# Blackstone River Valley National Heritage Corridor Commission Blackstone Canal Alternative Transportation Feasibility Study Uxbridge and Northbridge, MA

NPS Contract No. GS-10F-0281R; VHB Project No. 33281.02  
Document No.

**Figure 5**

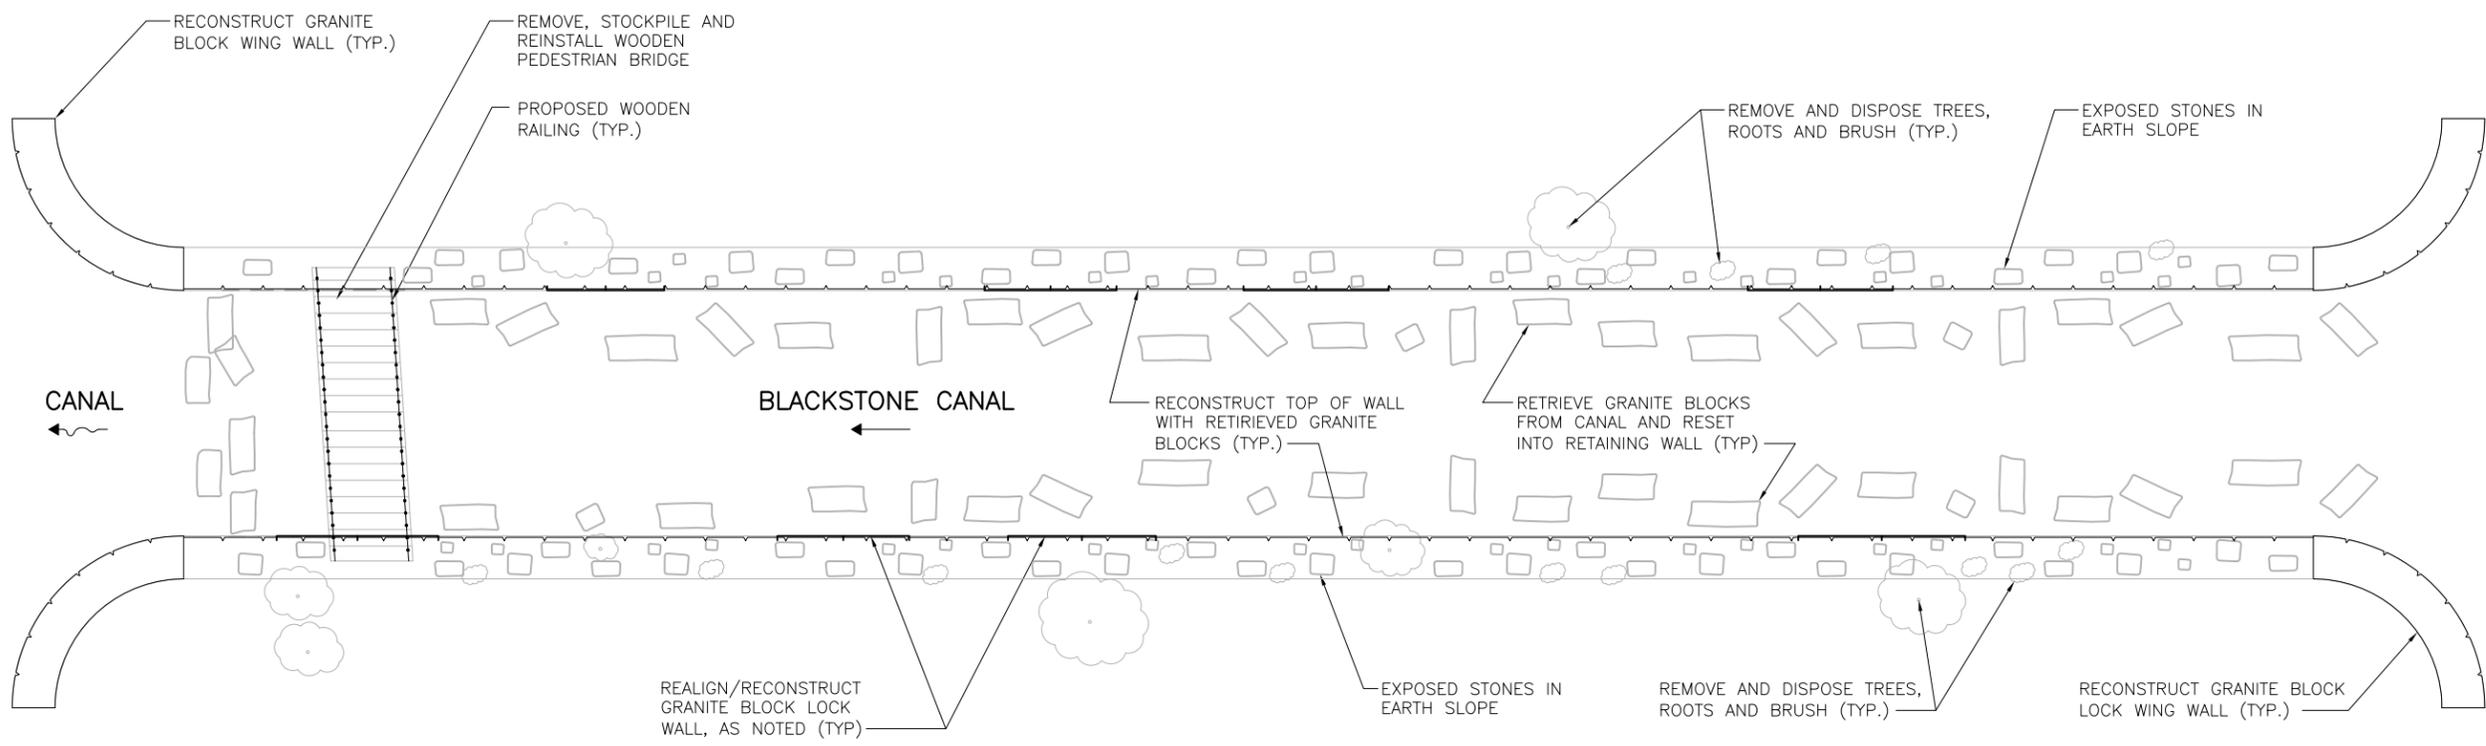
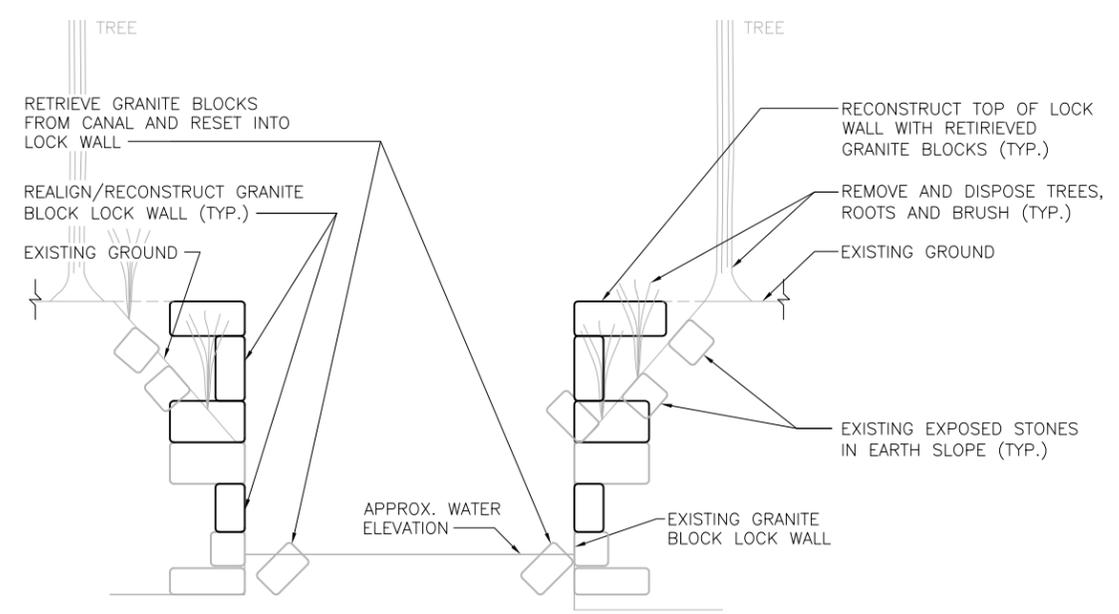
Figure 5, Goat Hill Lock . Leonard Loparto notes that he was under the impression that the lock walls were flared on the downstream side of the locks.
